Access Compliance Report

Public Rights-of-Way

Intersection ID: 46915	Main Street: RAISIN_TREE_LN	Cross Street: PONDEROSA_PINE_LN	Location: E
ADA ID: C70B97937982	Ramp Type: Perp	Initial Pass/Fail: Pass	Overall Compliance: No
Severity Score: 5			
Codes/Mitigation Info/Possible Solution		Field Measurements/Component Compliance

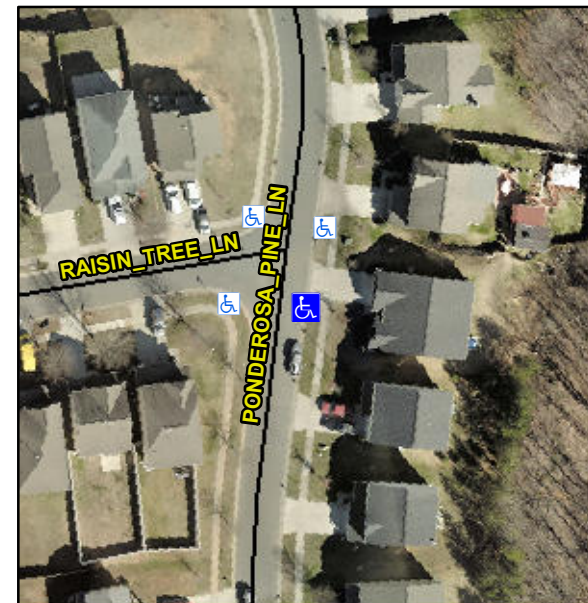
**Remove & Replace Entire Ramp.
Remove & Replace Gutter.**

**Not Found, R304.2.2-Perp, R304.3.2-
Para, R304.5.3, R304.5.4**
